ADDENDUM NO. 1

EAST PATROL OPERATIONS DIVISION NORTH RENOVATIONS RE-BID
(10% MBE PARTICIPATION GOAL)

January 29, 2026

SHEET NO.
E4.1

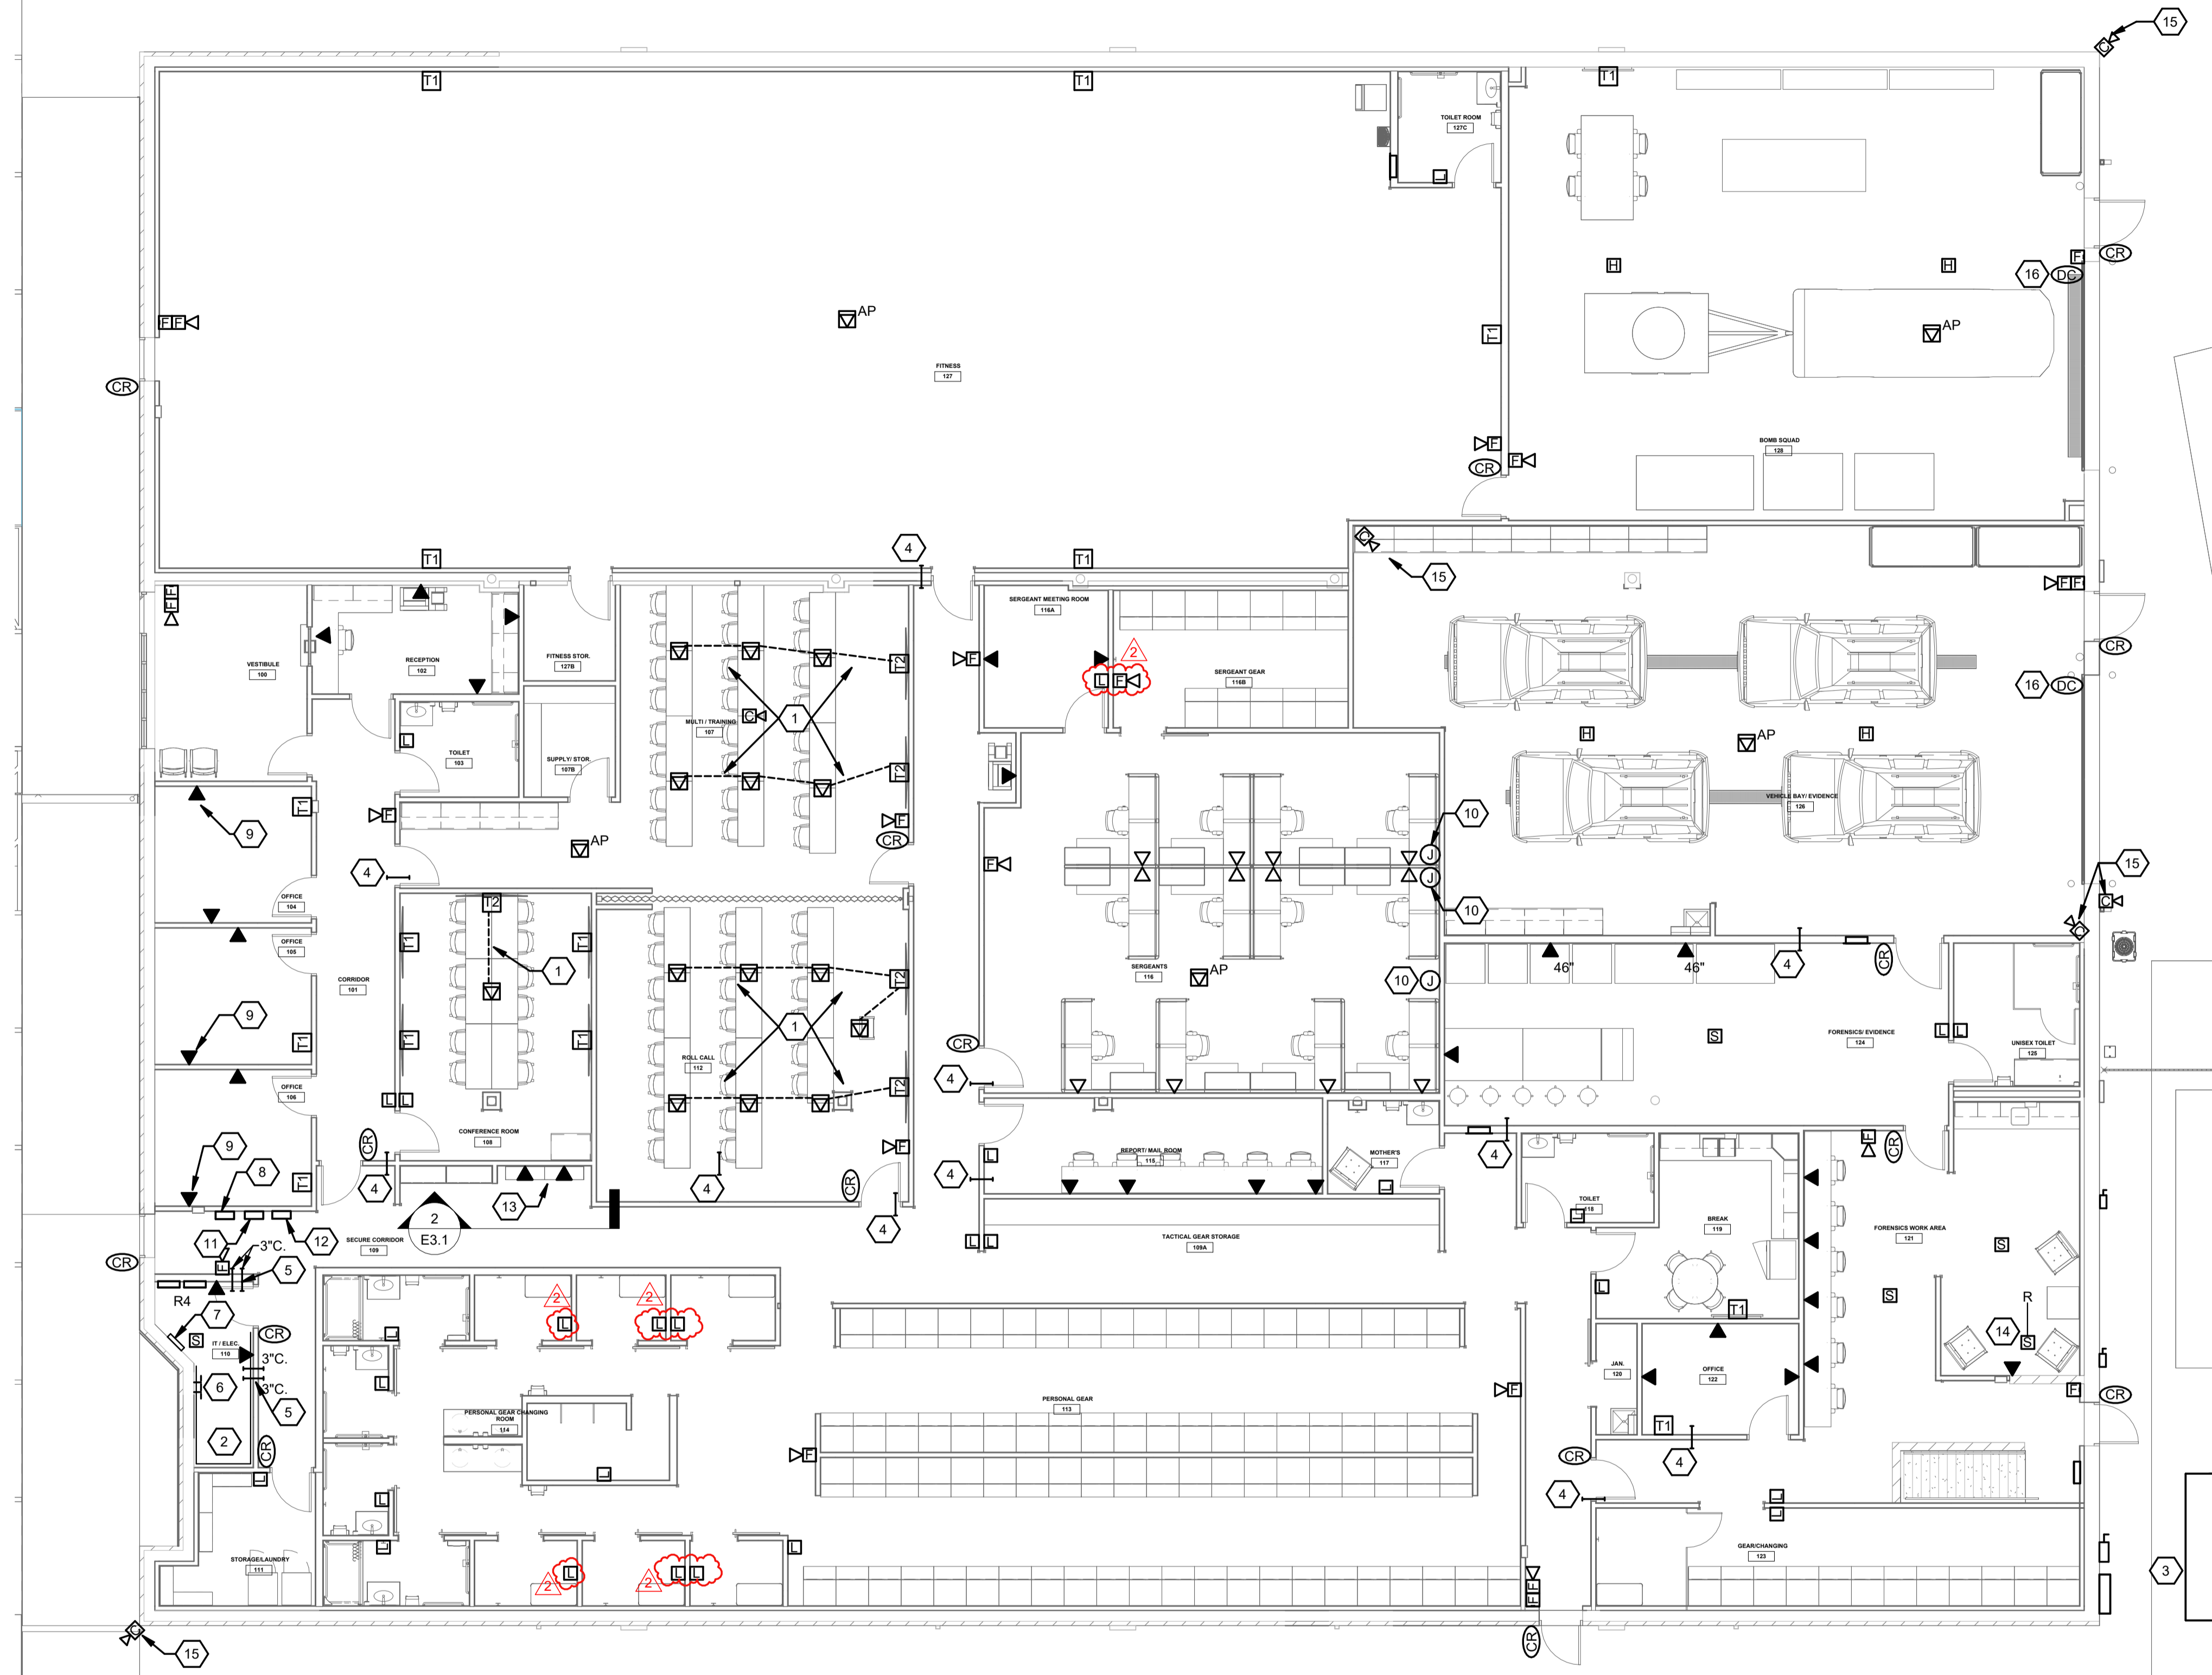
Sheet E4.1: Added fire alarm devices
